3/4.8 ELECTRICAL POWER SYSTEMS

3/4.8.1 A.C. SOURCES

SAFETY EVALUATION FOR CHANGE
TO THE A.C.SOURCES - OPERATION
TECHNICAL SPECIFICATION

LOAD DESCRIPTION

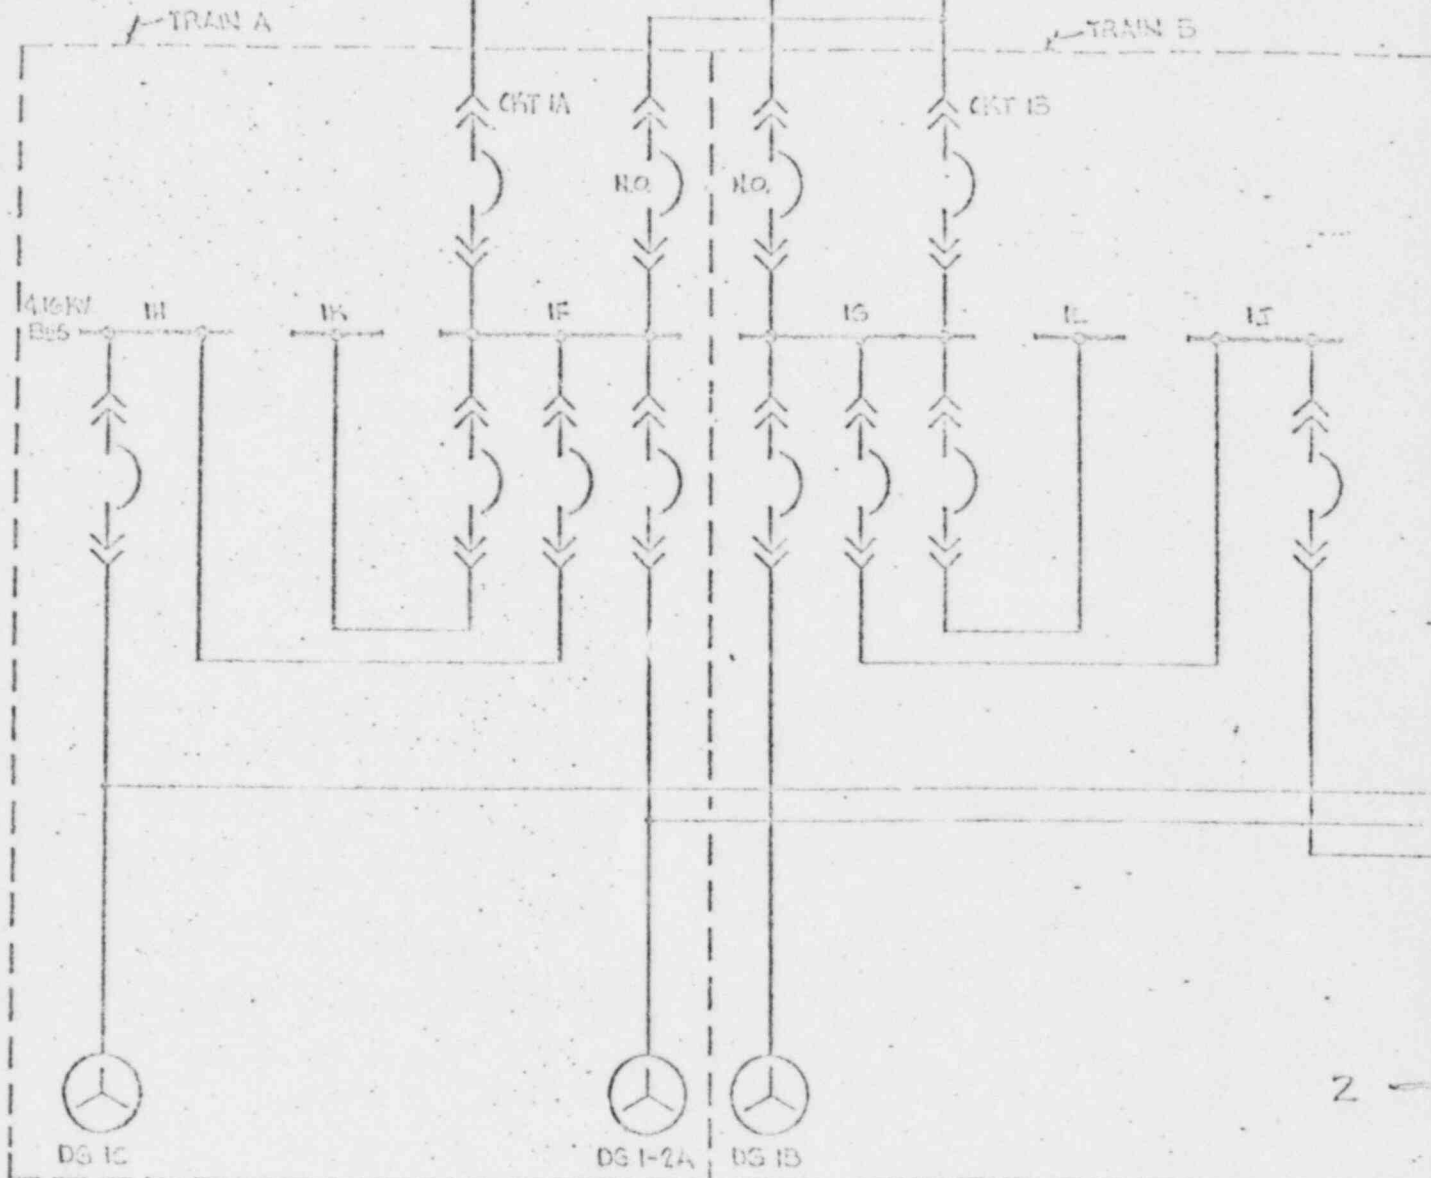
The loss of diesel generator 1C has no impact on either unit for case 2, 3, 6 or 7 due to the fact that D.G. 1-2A loads the essential buses and D.G. 1C does not pick up any emergency buses. The loss of D.G. 1C for case 1 results in a loss of Train A loads for Unit 2. The loss of D.G. 1C for cases 4 or 5 results in a loss of Train A loads for Units 2 or 1 respectively.

Figure 1 provides a description of the Farley emergency electrical distribution loads.
